# FUNCTIONAL ANALYSIS - VE PAYS

## FIRE PROTECTION CONTROL SCHEMATIC

DIVISION	11/25/92	MISCELLANEOUS REVISIONS	RT	
	DATE	DESCRIPTION	BY	BY
NORMAN ENGINEERING CO. CONSULTING ENGINEERS LOS ANGELES, CALIFORNIA			DEPARTMENT OF THE ARMY SACRAMENTO DISTRICT, CORPS OF ENGINEERS SACRAMENTO, CALIFORNIA	
DESIGNED:	MCCLELLAN AIR FORCE BASE		CALIFORNIA	
DRAWN:  D. LOPEZ	ADAL DEPOT CORROSION CONTROL FACILITY			
CHECKED:  K. GOODWIN	NEW AIRCRAFT PAINT FACILITY			
FIRE PROTECTION PLAN-SOUTH SIDE				
SUBMITTED:	DATE APPROVAL:	SCALE:	SHEET NO.	SPEC. NO.
	9/30/92	1" = 1'-0" CORNERS FP-2 70 x 95	FILE NO.	8529
		100-25-2051

REVISION	DATE	DESCRIPTION	BY	BY
1	11/25/92	ADDED NOTE	RT	
DESIGNED BY		DEPARTMENT OF THE ARMY		
DRAWN BY		SACRAMENTO DISTRICT, CORPS OF ENGINEERS		
CHECKED BY		SACRAMENTO, CALIFORNIA		
L. MYERS		MCCLELLAN AIR FORCE BASE		
R. TAGAYUN		ADAL DEPOT CORROSION CONTROL FACILITY		
R. SHEPARD		NEW AIRCRAFT PAINT FACILITY		
L. MYERS		HAZARDOUS AREAS - PLAN & SECTIONS		
SUBMITTED	DATE APPROVED	SCALE: $\frac{1}{16}'' = 1'-0''$	SPEC No.	8529
11/25/92	9/30/92	SHEET E-2	FILE No.	100-25-2051

FP-1 FP-4

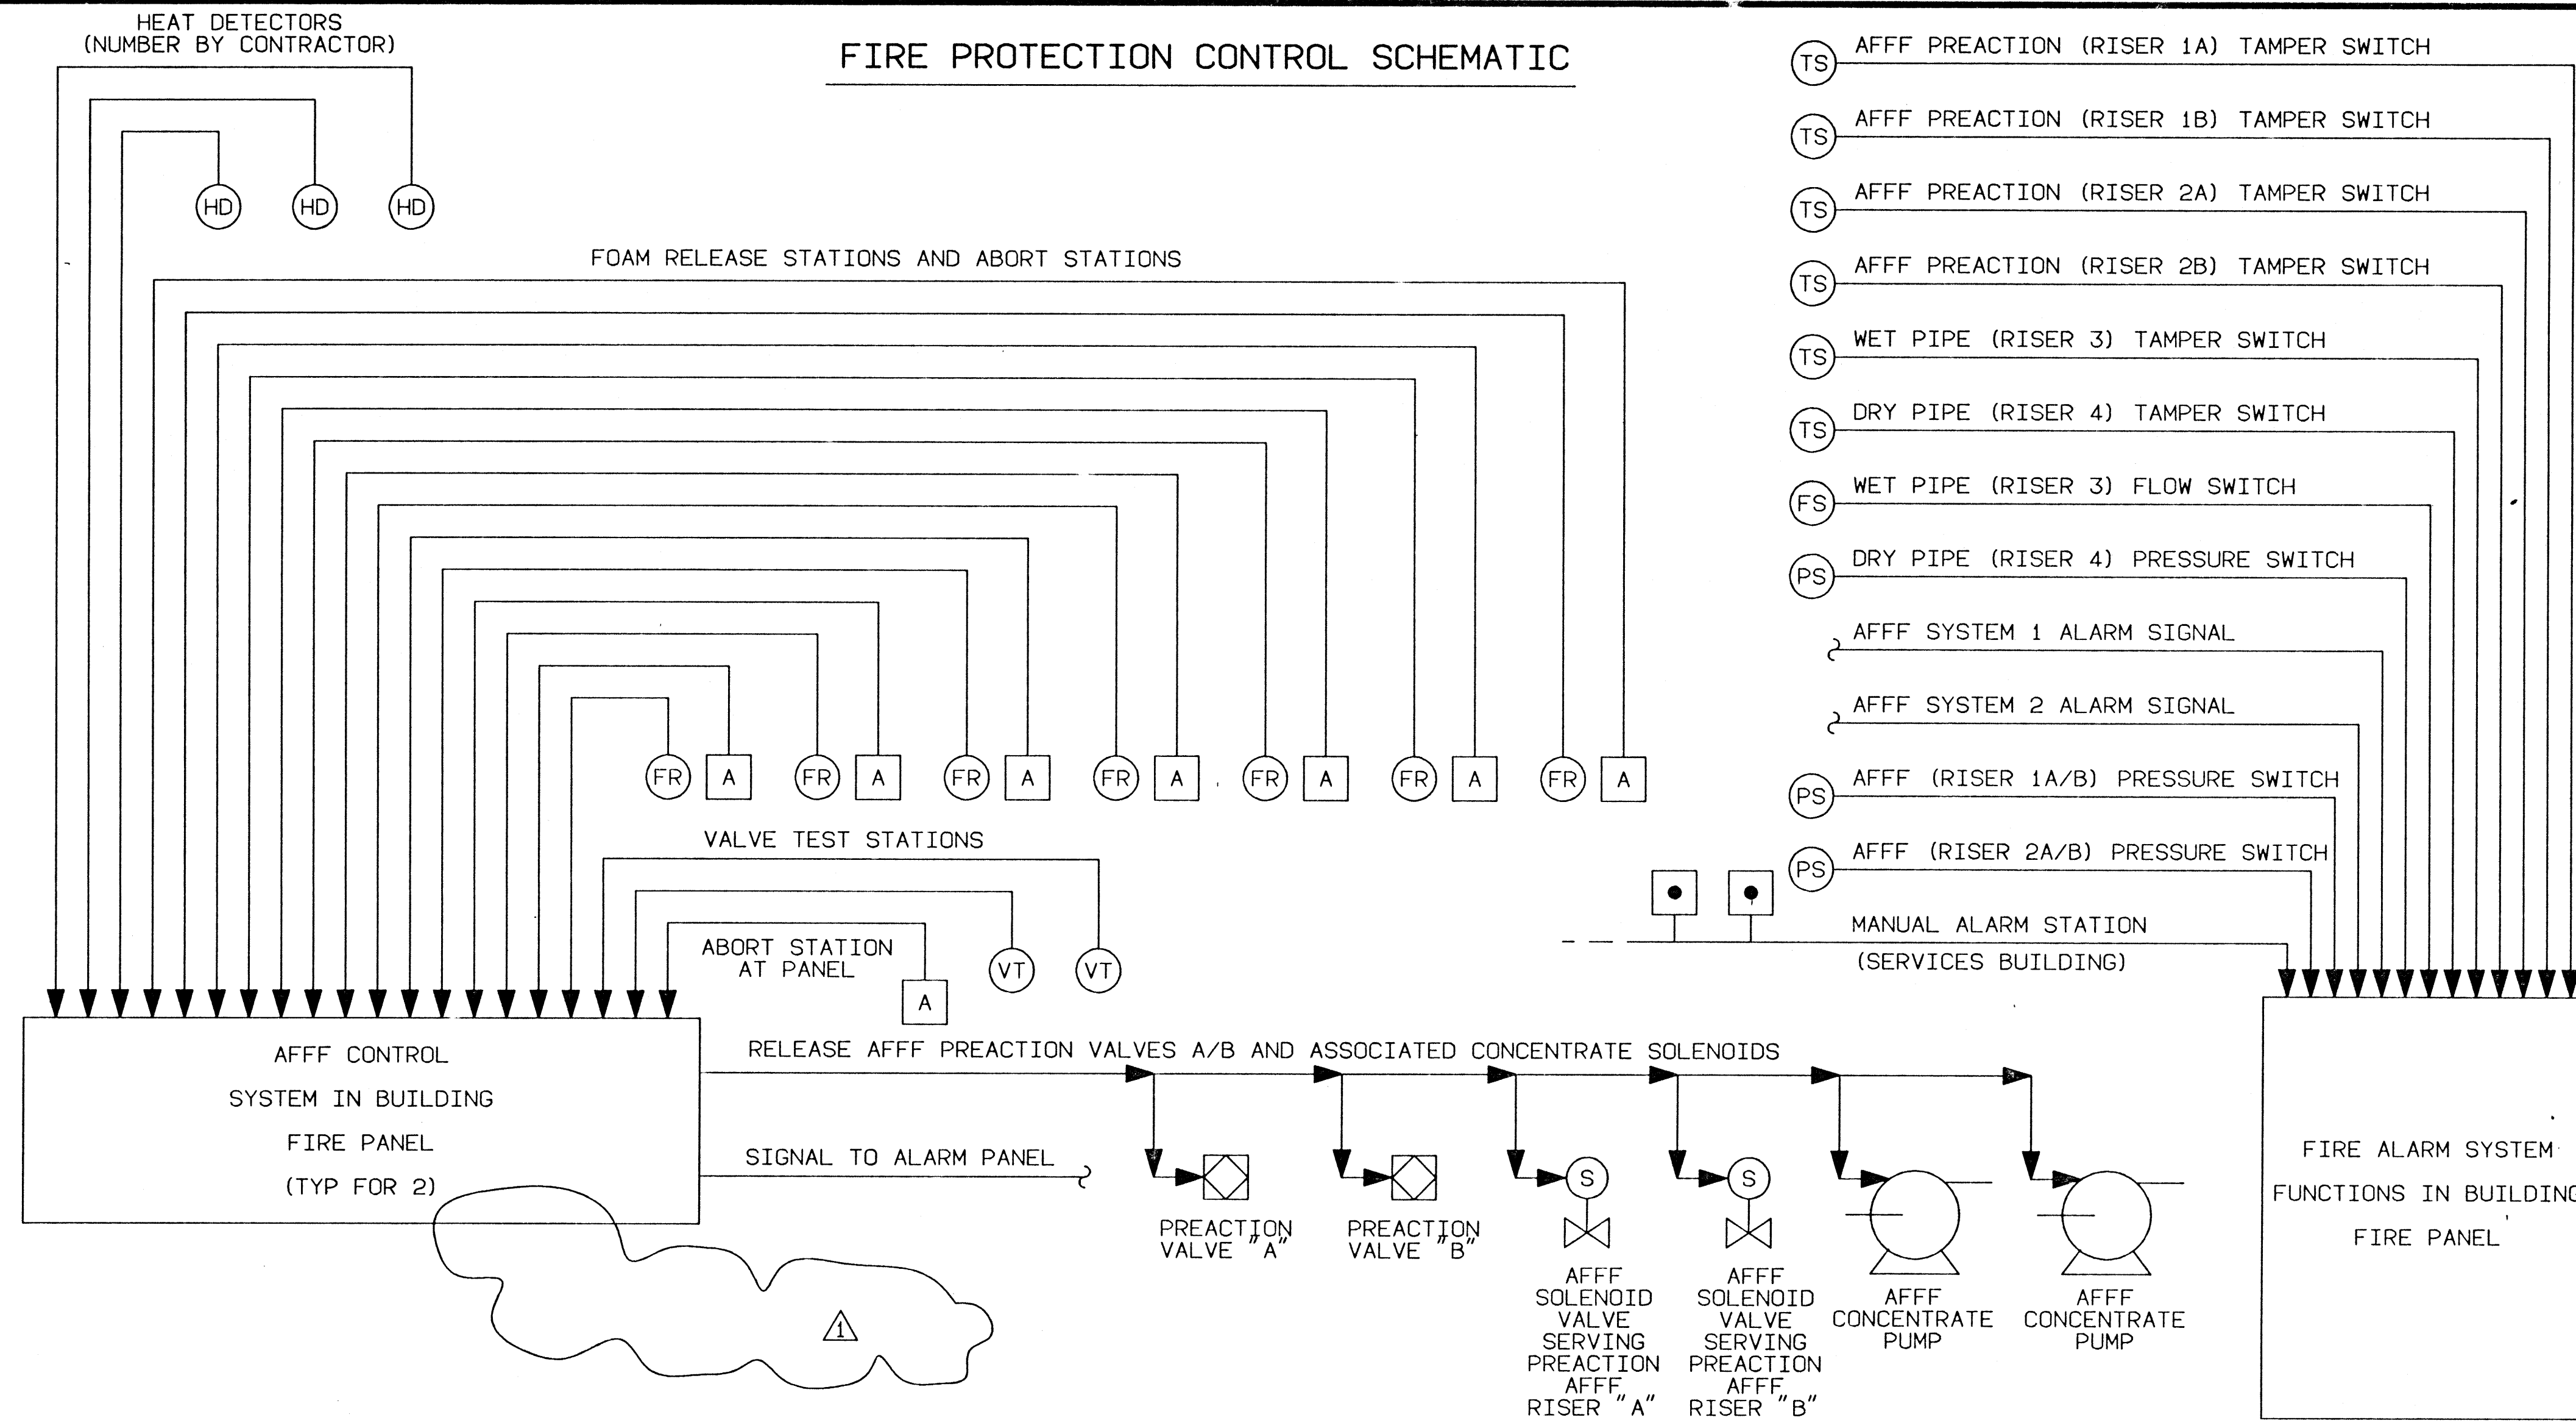
- HEAT DETECTION SYSTEM WILL NOT BE CROSSED-ZONE PER RFI #60
- SEE SHTS M4, M6, M7, M12 FOR SMOKE DETECTOR/FA SYS. TIE-IN RFP 10, P00013, RFI-19
- SEE SHT E22 FOR RFI 92 REGARDING EXISTING BLDG 692 FA PANEL NOT PROVIDING ENOUGH SPACE FOR NEW WORK. ALSO RFP #40 P00032

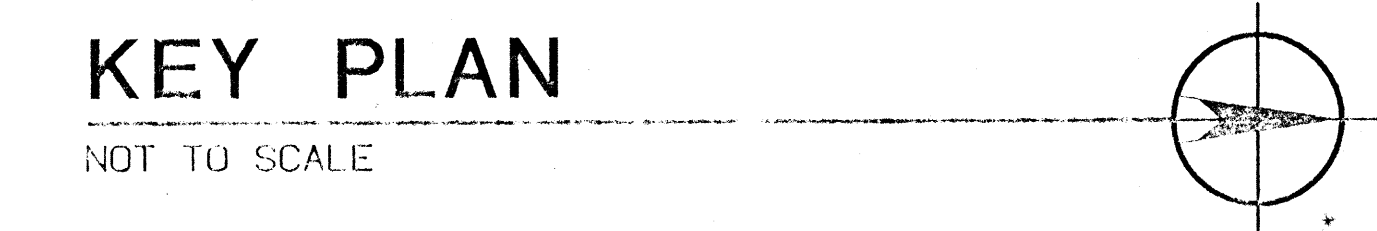
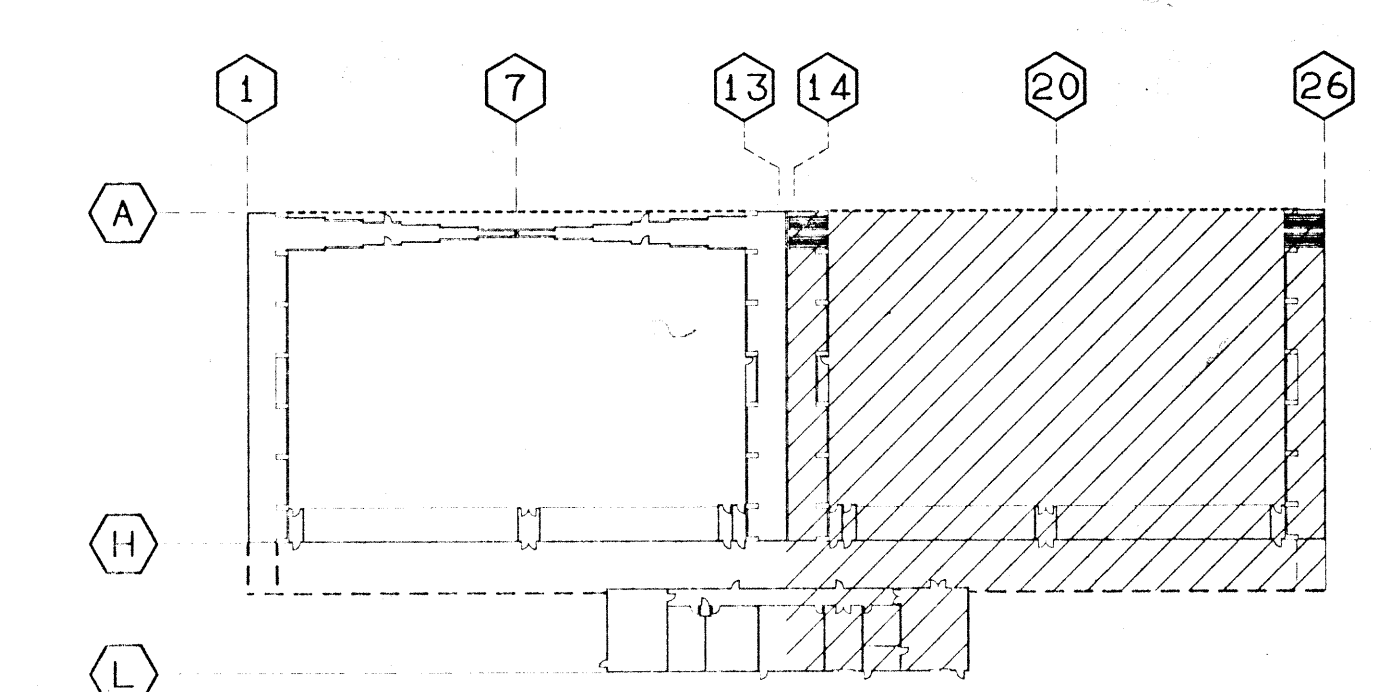
~~Drawing Sheets FP-2 and FP-3:~~ *Addendum No 0006*  
Add the following: Outside hose stream shall be 500 gpm and is indicated on Sheet C-7 to be fed from the domestic water system. But for the AFFP system, no fire hydrants are to be assumed. Simultaneous operation of the AFFP system and the other systems is not to be assumed. For information only: the 500 gpm hose stream mentioned above will serve as the hostream for the AFFP system.

HAZARDOUS AREAS

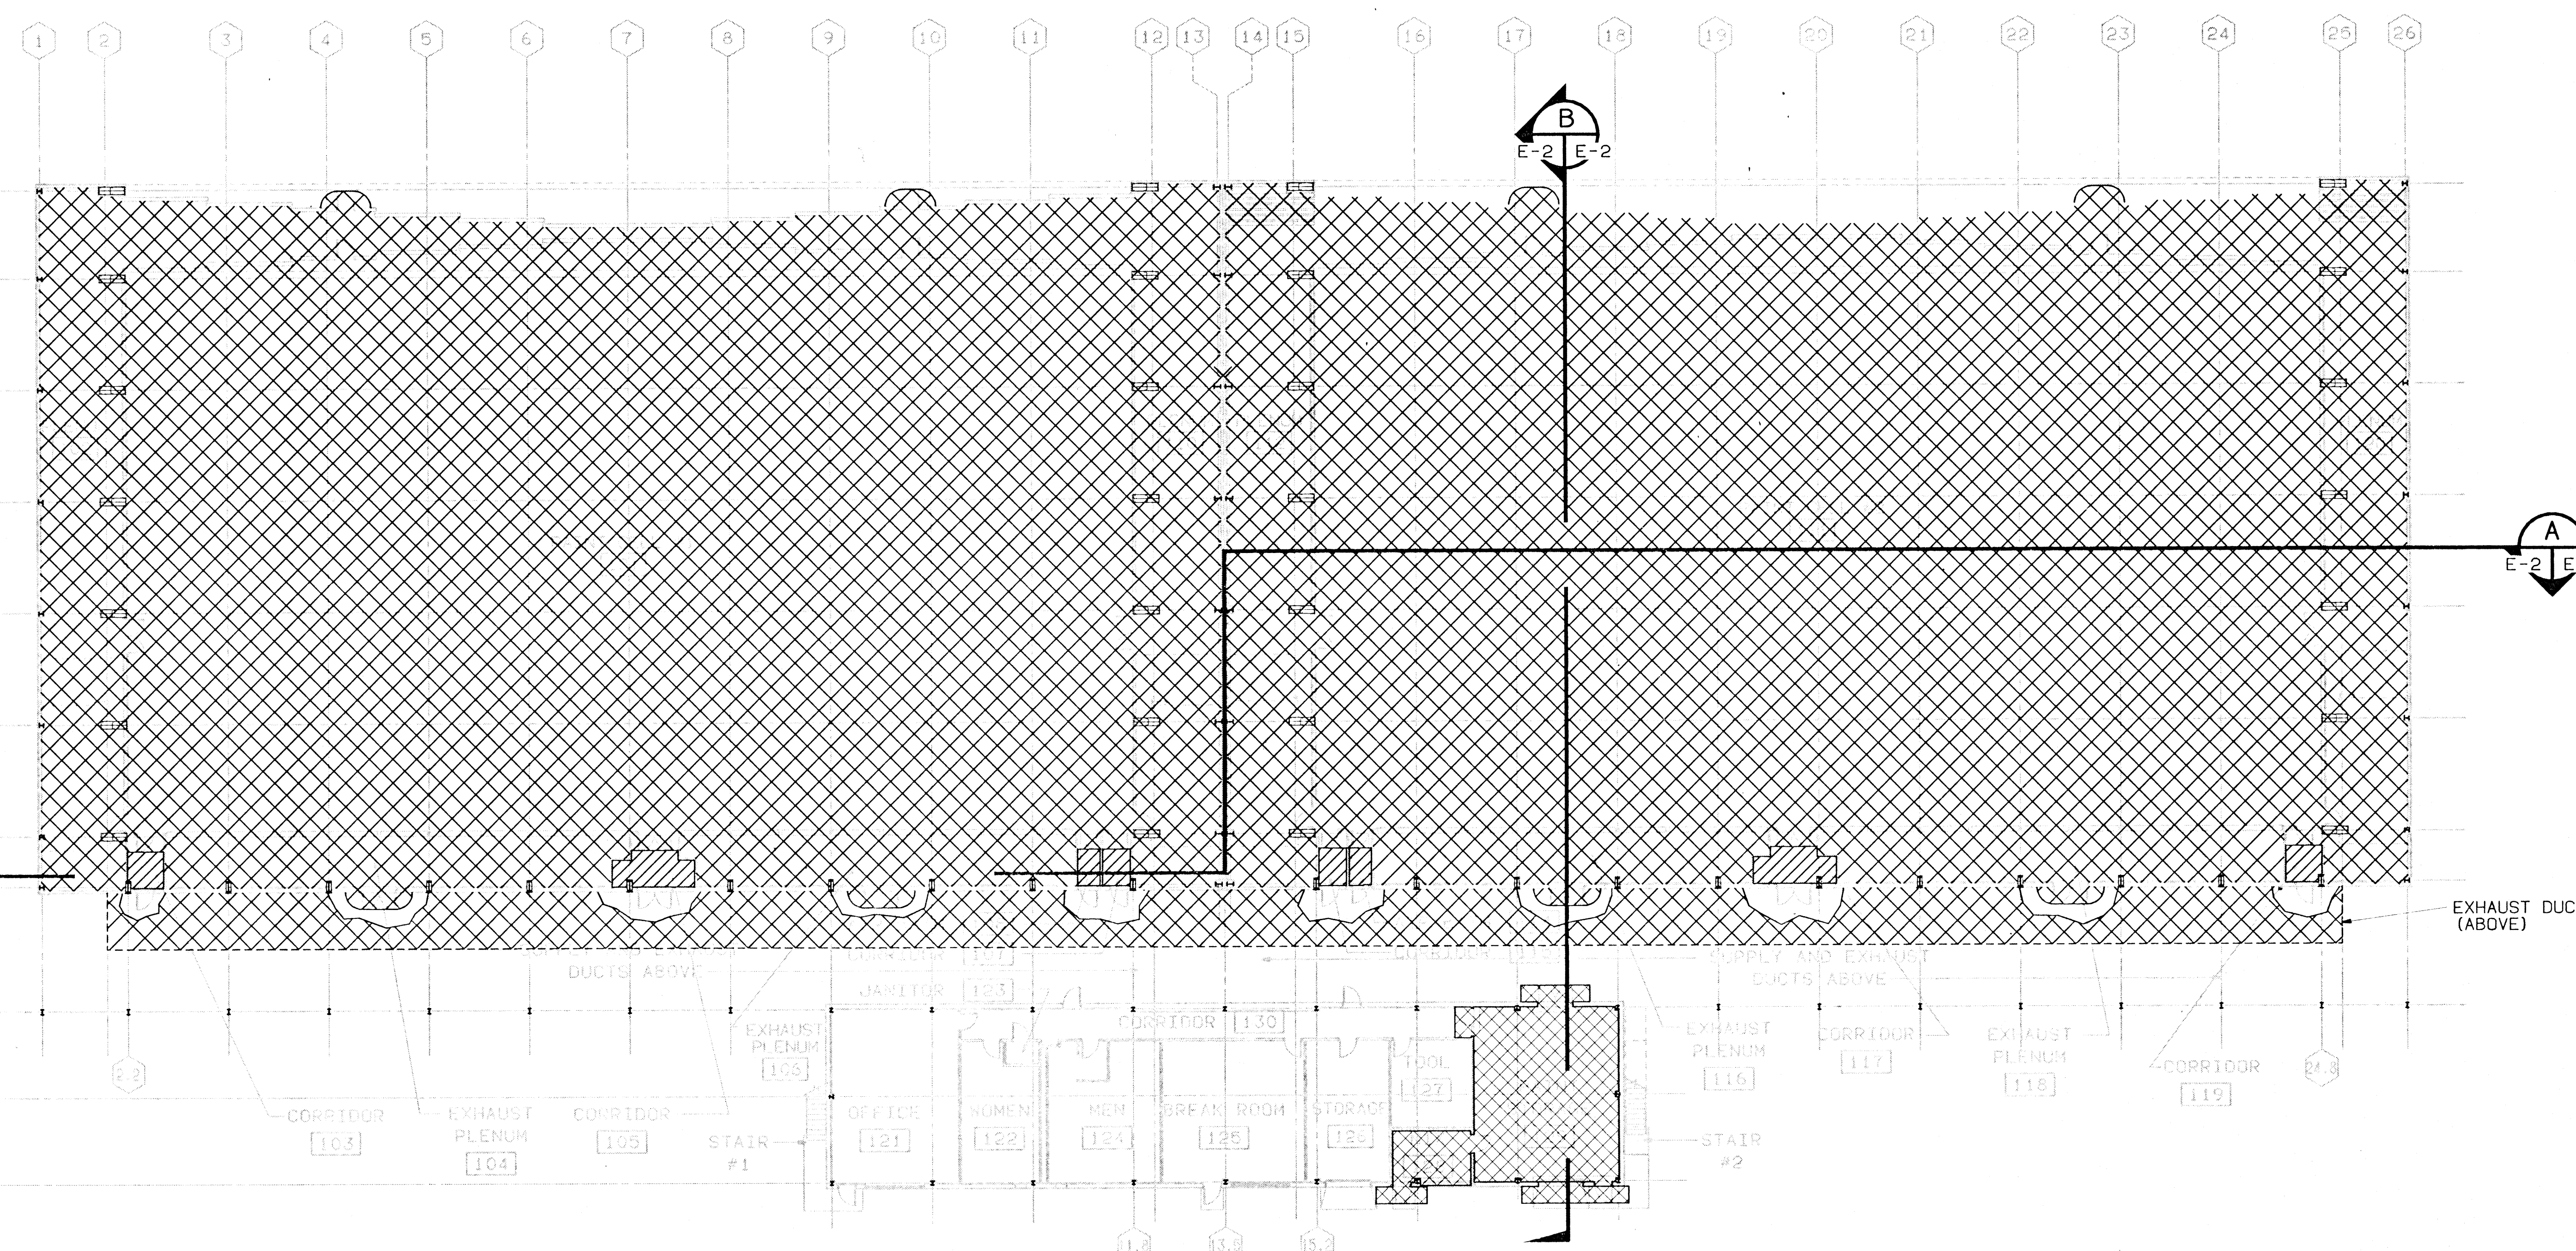
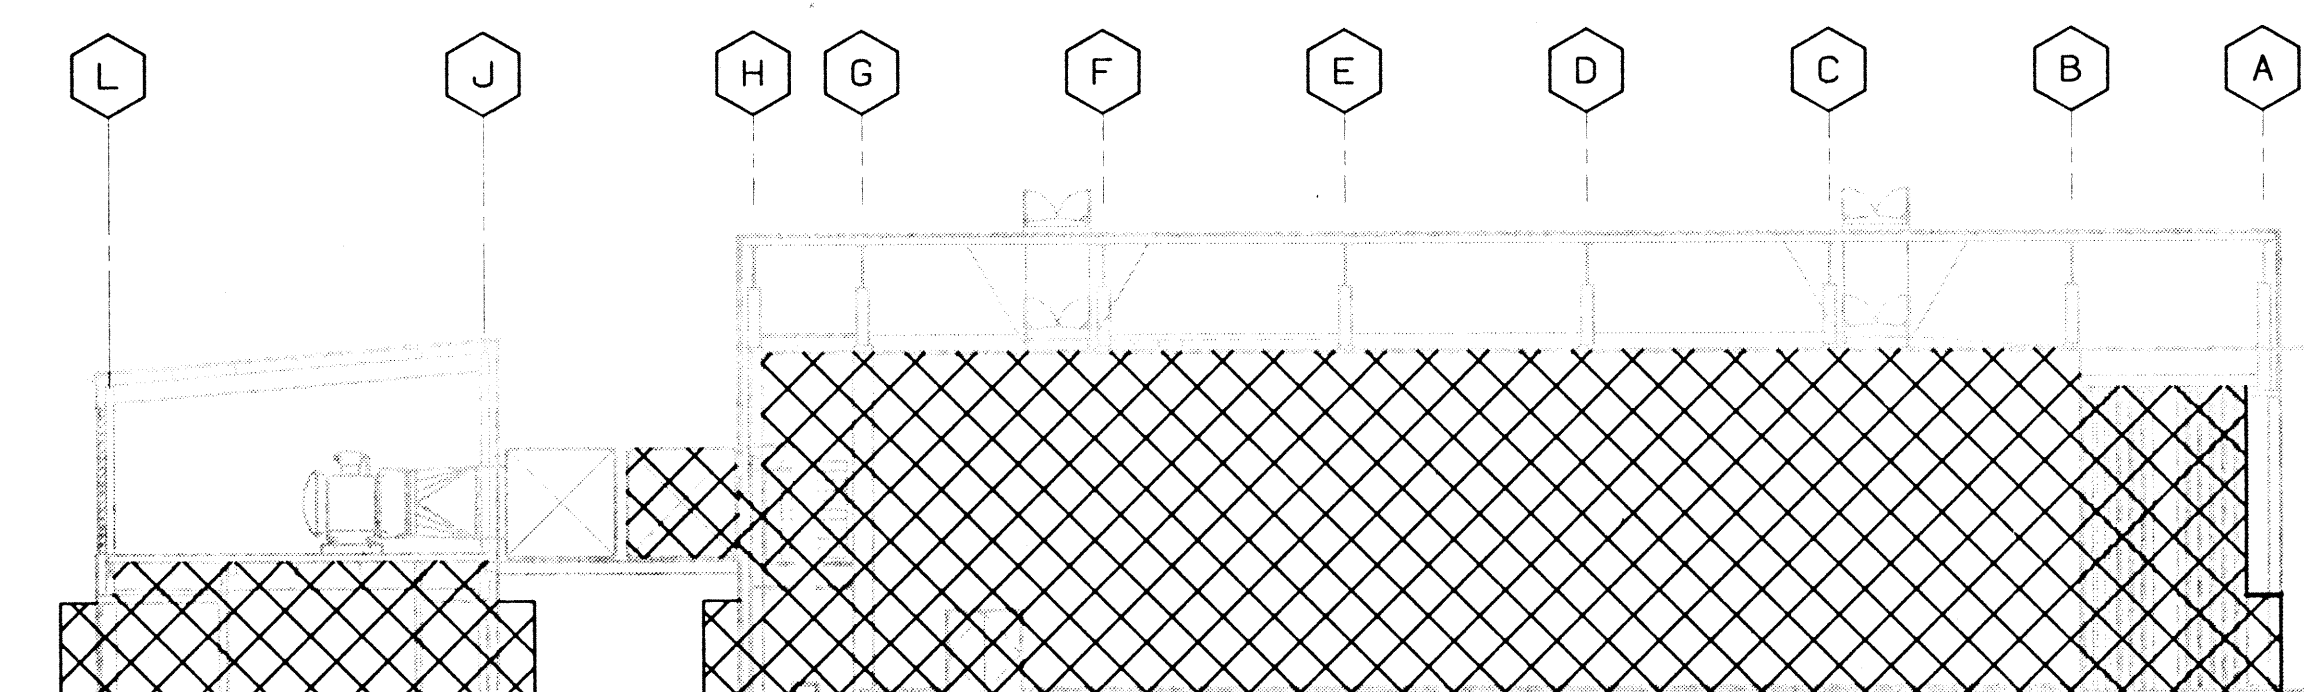
Reference your RFI #72, dated January 19, 1994, regarding the branch circuit conductors running underground in the Class 1 Division 1 hazardous area, as defined by the contract drawing sheet E-2. A review of your attached drawing produced the following comments:

- a. The seal-off located at the conduit stub-up shall be relocated to immediately outside the classified boundary. The seal-off can be located at the adapter between the rigid steel and rigid non-metallic conduit, but there shall be no fittings between the boundary and the seal-off. Reference NEC article 501-5(a)(4).
- b. All conduit seal-offs shall remain accessible. Reference NEC article 501-5(c)(1).
- c. Seal-offs will be required within 18 inches of each electrical device that is not factory sealed. Reference NEC article 501-5(d)(1).
- d. Steel conduit in contact with earth shall be protected against corrosion. Reference specification section 14415 paragraph 3.2.2.1.
- e. Conduit installed within the slab on grade shall comply with specification section 14415 paragraph 3.2.2.2.
- f. Conduit crossing a structural joint shall be installed to comply with section 14415 paragraph 3.2.2.
